ON-SITE SEWAGE DISPOSAL SYSTEM HOWARD COUNTY HEALTH DEPARTMENT BUREAU OF ENVIRONMENTAL HEALTH

ADDRESS: 16058 Ed Warfield Rd. PROPERTY OWNER: Tim McIntosh

TRENCHES:	Trench to be _____ feet wide. Inlet _____ feet below original grade. Bottom maximum depth _____ feet below original grade. Effective area begins at _____ feet below original grade. _____ feet of stone below distribution pipe.
LOCATION:	Install Advantex tank after existing tank in line with existing drywell. Old tank to be pumped and collapsed.
NOTES:	This permit under the BRF BAT for the installation of an AdvanTex AX 20 model 3a unit.

Approved Septic System Plan
Howard County Health Department

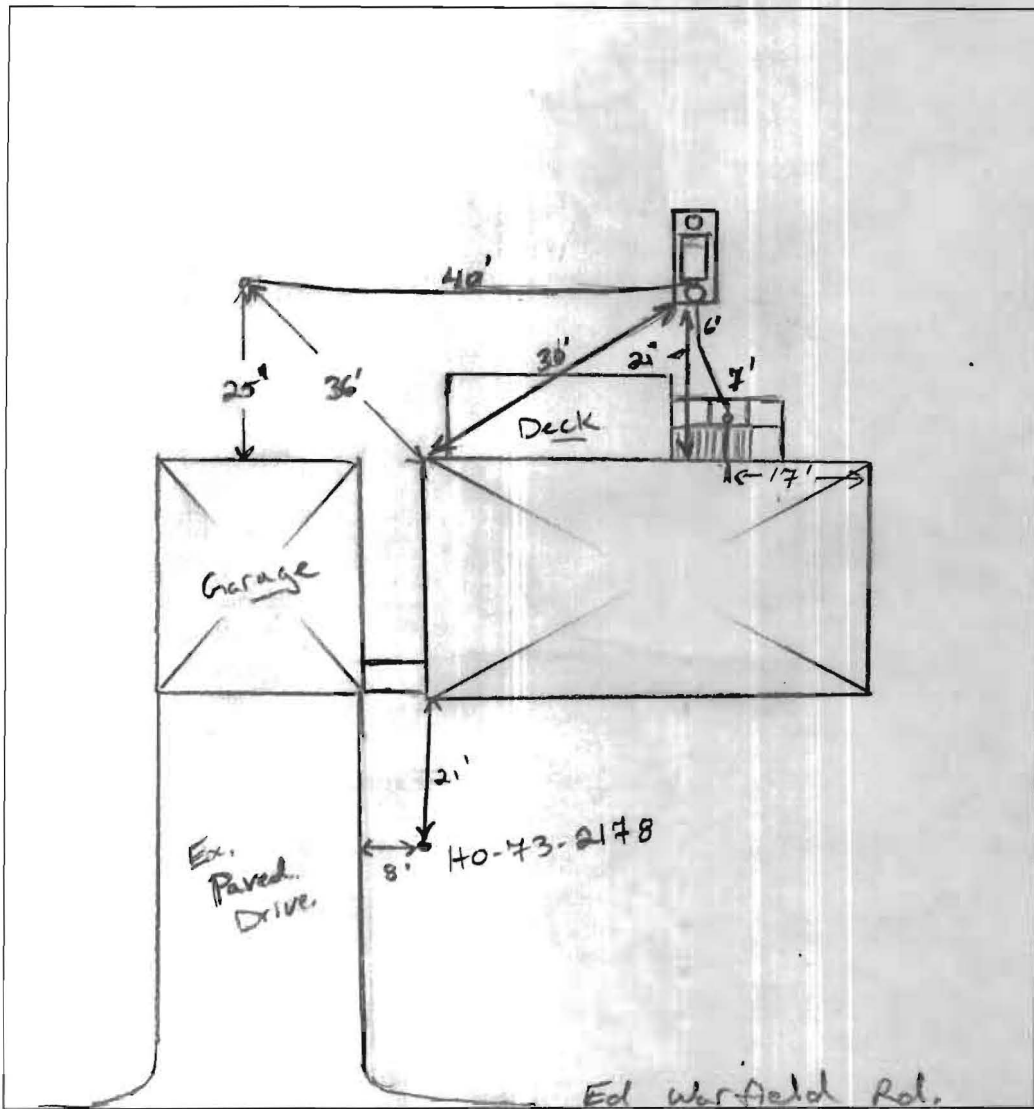
Site plan ok to
set BAT Advantex
AX 20 mech 3c unit

LOCATION DIAGRAM

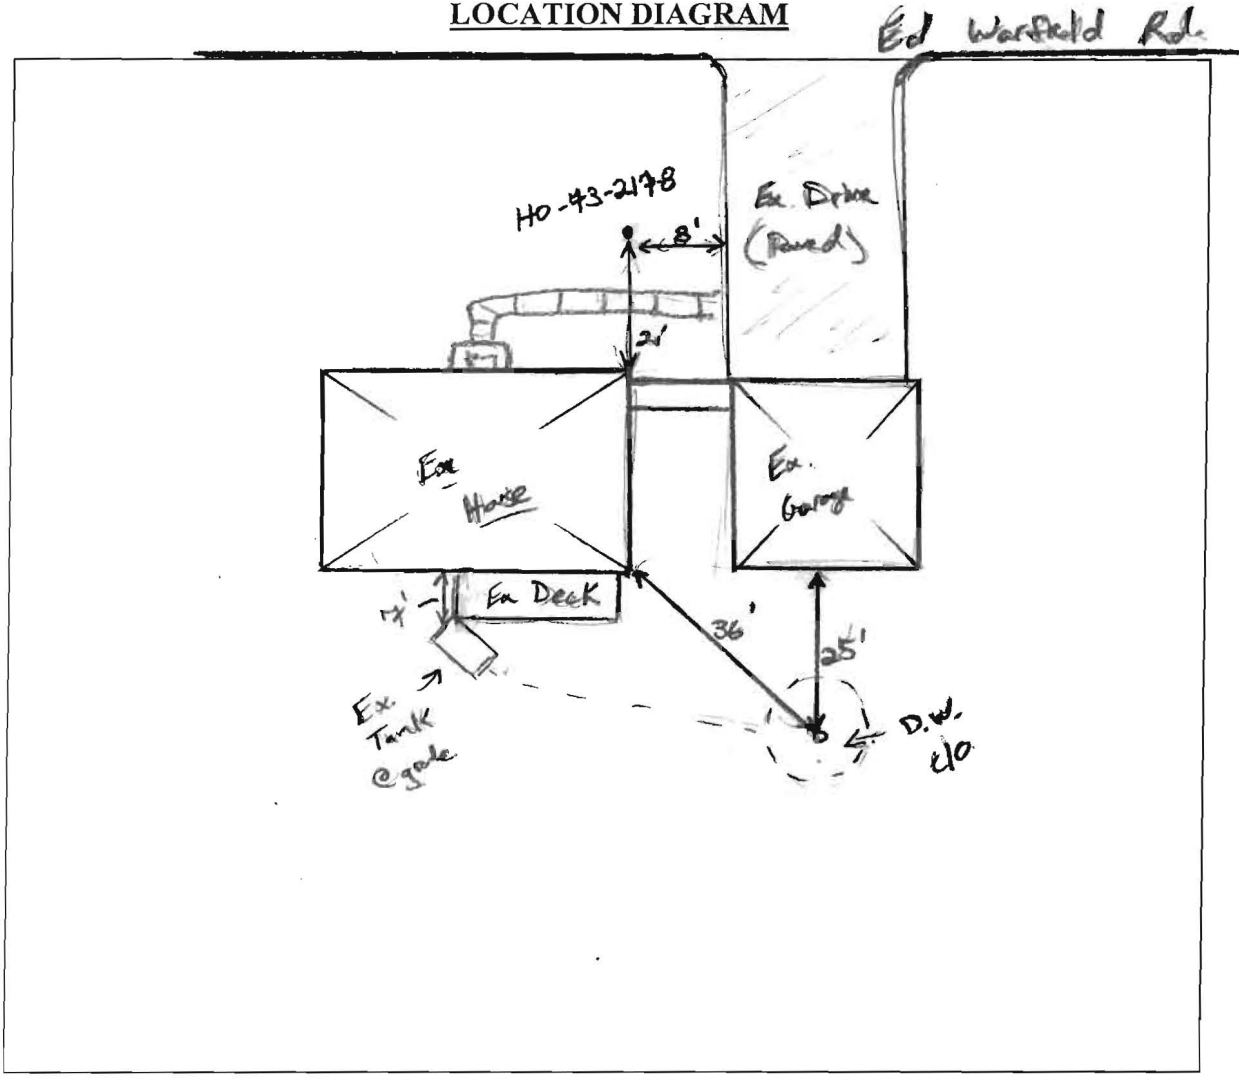
COMMENTS: Existing well up to code. Existing Septic tank @ grade. Could not open clo to DWS. New BAT tank will probably encroach w/ in 100' of well Radius. (KW)
